10/617,982

AMENDMENT IN RESPONSE TO OFFICE  
ACTION MAILED NOVEMBER 1, 2005

Atty. Docket No. 200-65500  
(PB030022AF)

FIG. 2

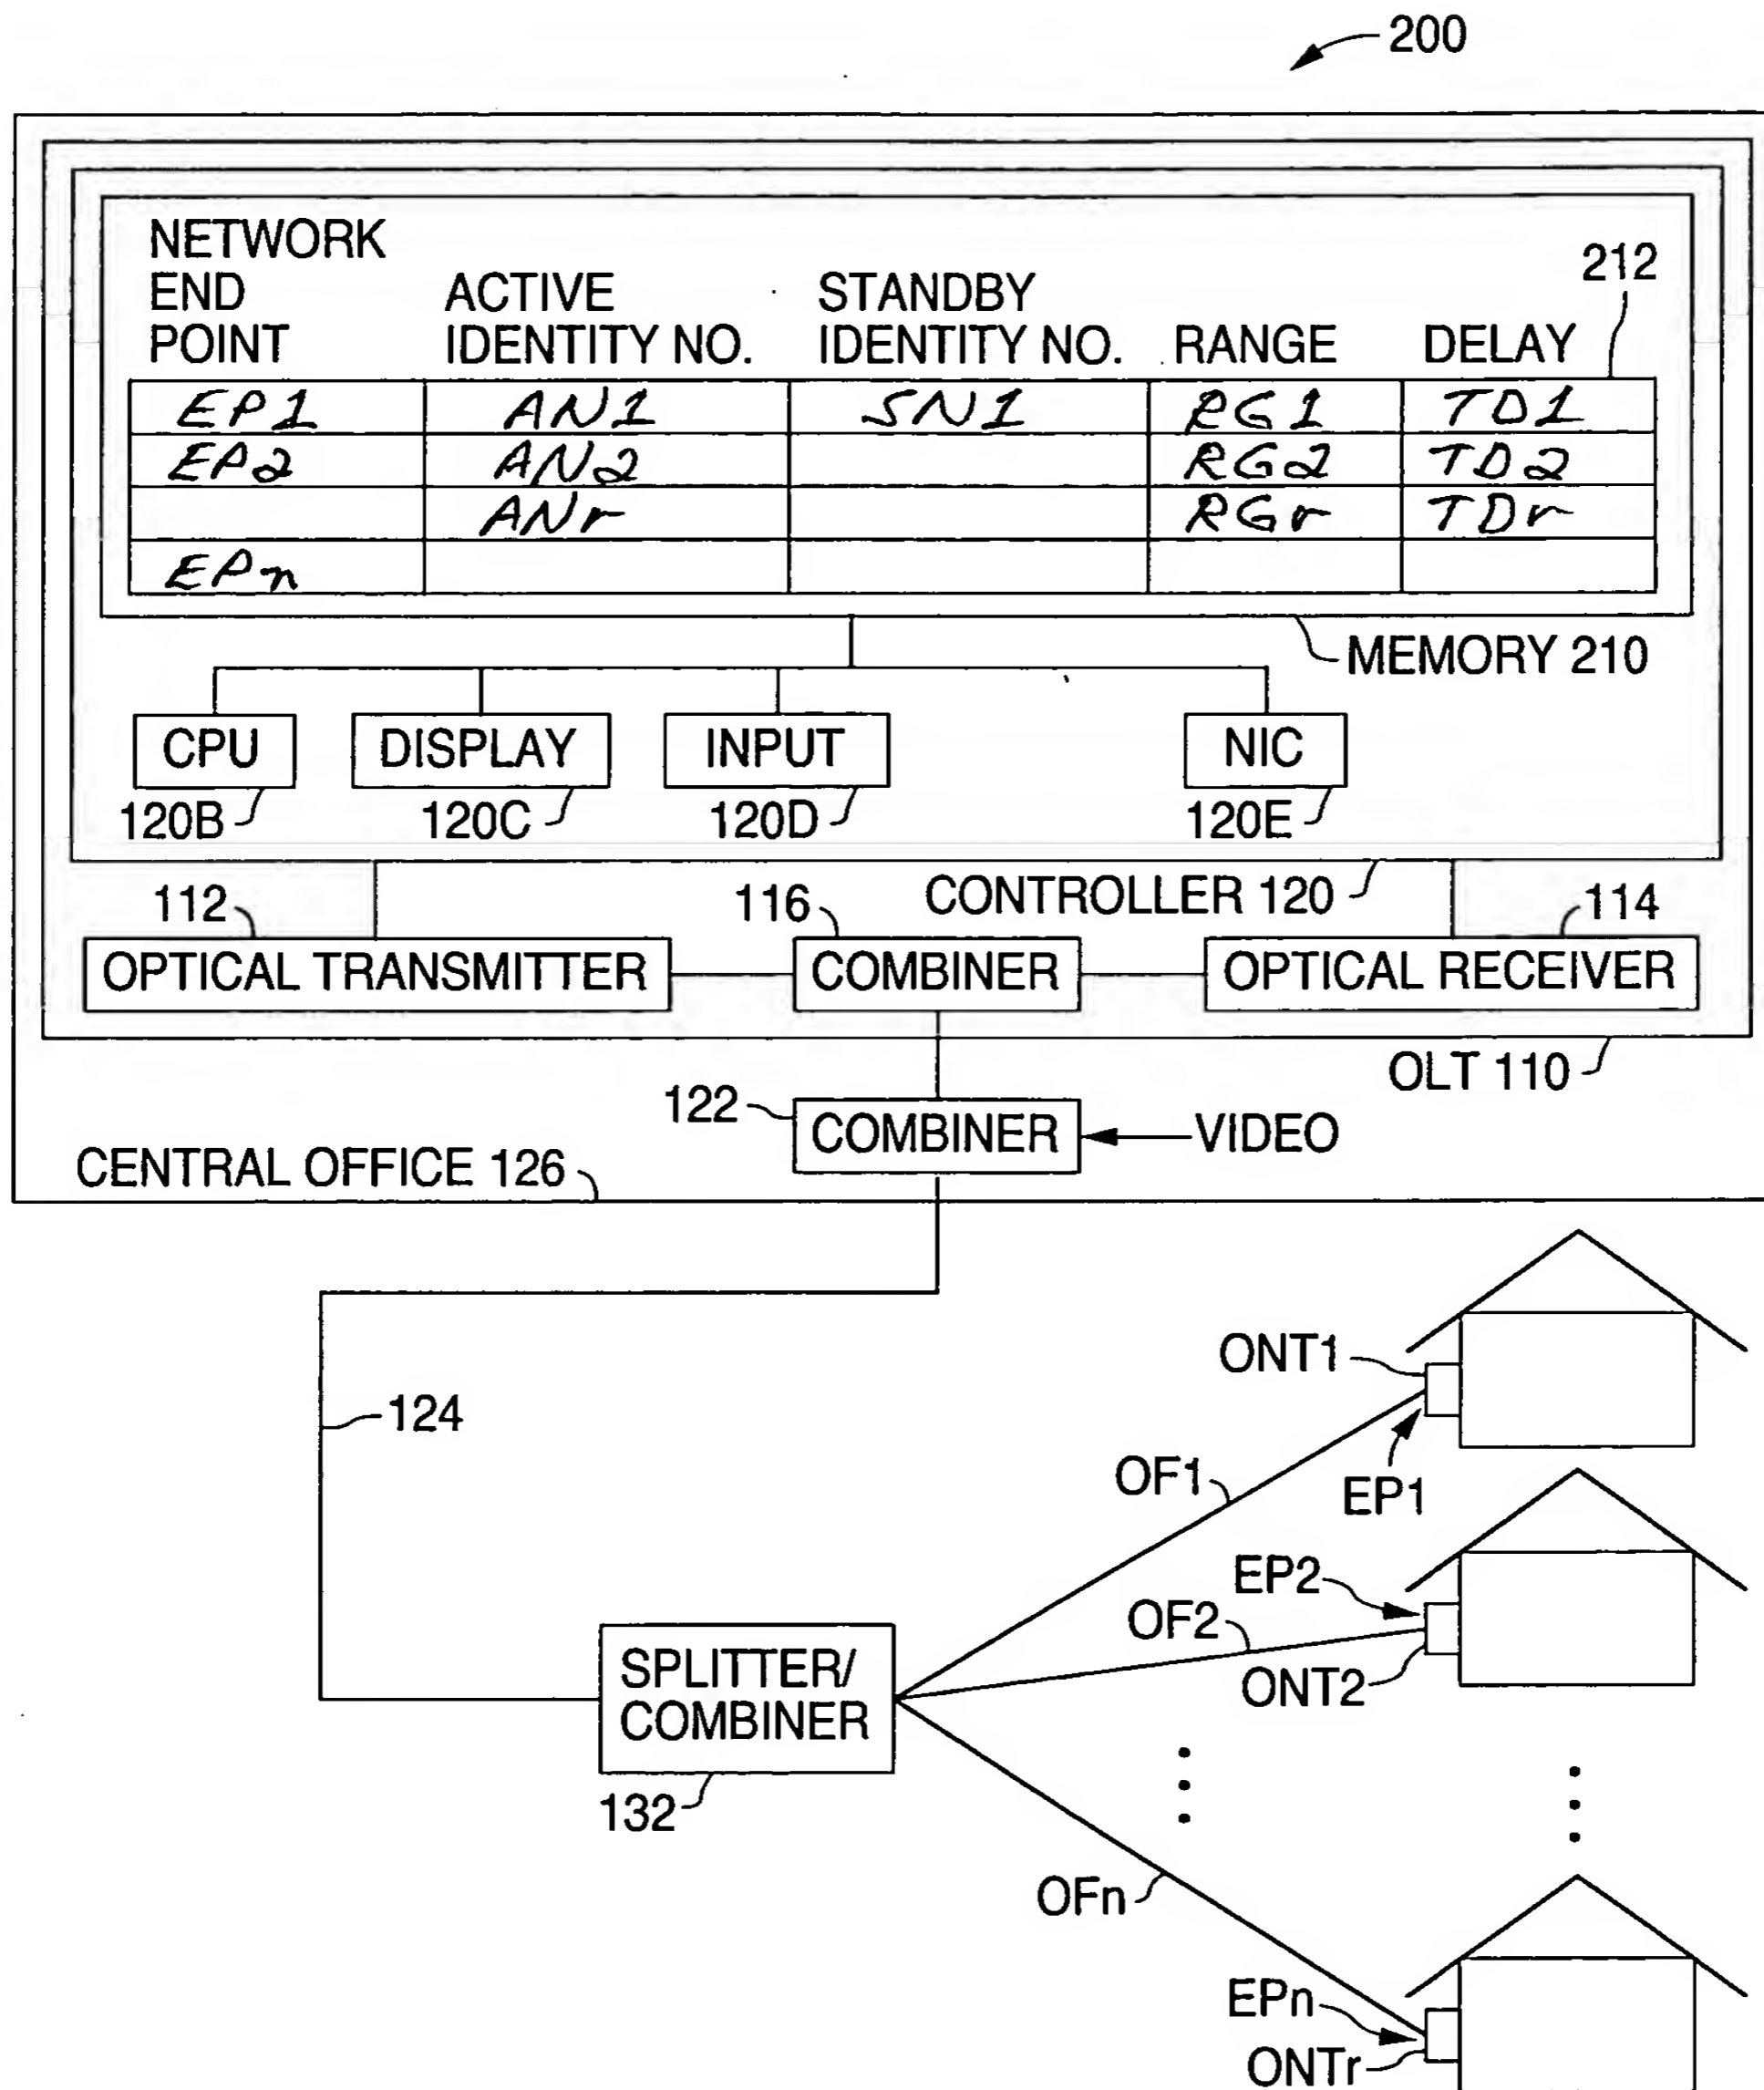
The Examiner objected to the drawings under 37 CFR §1.83(a) because the drawings do not show a memory that stores a first identification number that represents a first optical device that is associated with a network end point, and a second identification number that represents a second optical device that is associated with the network end point.

However, in order to further prosecution, applicant's specification has been amended to list reference numerals for the active identity numbers (AN1-ANr) of the optical network terminals ONT1-ONTr used at the network end points, the ranges (RG1-RGr) to the optical network terminals ONT1-ONTr, and the transmission delays (TD1-TDr) assigned to the optical network terminals ONT1-ONTr.

In addition, FIG. 2 has been amended as shown in red to place the reference numerals for the network end points (EP1-EPn), the active identity numbers (AN1-ANr), the ranges (RG1-RGr), and the transmission delays (TD1-TDr) in table 212. Amended FIG. 2 is attached in Appendix A, and a replacement sheet for FIG. 2 is attached in Appendix B. As a result, the drawings are believed to satisfy the requirements of 37 CFR §1.83(a).
